Variance Request Form

PG&E Hollister 115 kV Power Line Reconductoring Project

Variance Request No.: 11

- Attachment A: Variance 11 Proposed Power Line Realignment Location Map
- Attachment B: Photographs

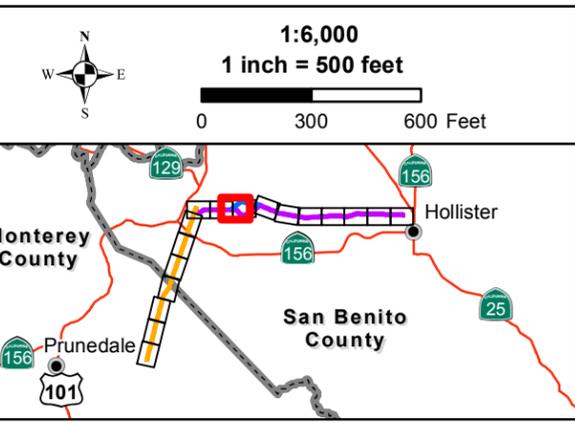
PG&E is requesting authorization from the CPUC to realign the power line route between Pole 14/09 and Pole 14/15 from the approved alignment described in the MND to along the edges of, rather than diagonally across, a parcel in active farmland. The entire proposed realignment (realignment) will be located on the same parcel as the original route, and will permanently affect only the land owner requesting it; however the temporary pull and tension work sites, PP-4B and a portion of the proposed relocated PP-3, are located on the adjacent property.

The realignment will result in two fewer new poles on the affected parcel because the power line will follow the existing power line, replacing existing poles, and the realignment only requires three poles in the agricultural field, instead of five poles. The realignment will follow the existing line for approximately 1,100 feet from Pole 14/09 to Pole 14/13e, which runs along an existing agricultural road. The MND states that Poles 14/10e through 14/13e would be topped and the power line conductors removed, leaving the existing underbuilt distribution line. However, the realignment will instead replace Poles 14/10e through 14/12e with light duty steel (LDS) poles and Pole 14/13e will be replaced with a tubular steel pole (TSP). The power line will be reconducted, and the distribution line transferred to the new poles. Access to the realignment is provided by existing agricultural roads.

From Pole 14/13e, the realignment will run north along the edge of the existing agricultural field for approximately 670 feet, then turn northeast for approximately 550 feet, where it intersects with approved Pole 14/15 along the approved route just before it crosses the San Benito River. This section of the realignment is closer to the San Benito River than the approved alignment; however, the poles will not be closer to the river than approved Pole 14/15, and all pull sites will be setback a minimum of 50 feet from water bodies, including the San Benito River, consistent with biological resource mitigation measures in the MND. No impacts on riparian vegetation or the San Benito River are anticipated as a result of the realignment.

As stated above, the realignment will result in two fewer new poles on the property. Although the realignment will require the installation of seven poles, which is two more than the five poles approved through the agricultural field, four of the proposed poles will replace existing Poles 14/10e through 14/13e and only three new pole locations will be required.

Three new pole pull (PP) sites will be required to pull wire along the realignment. PP-4A will be located east of Pole 14/13e; PP-4B will be located south of Pole 14/13e; and PP-4C will be located northwest of Pole 14/13e. In addition, due to the fact that the power line angle at Pole 14/09 will be eliminated, PP-3 is proposed to be relocated. All of the PP sites will be located in agricultural fields. No fueling will be conducted at these PP sites.
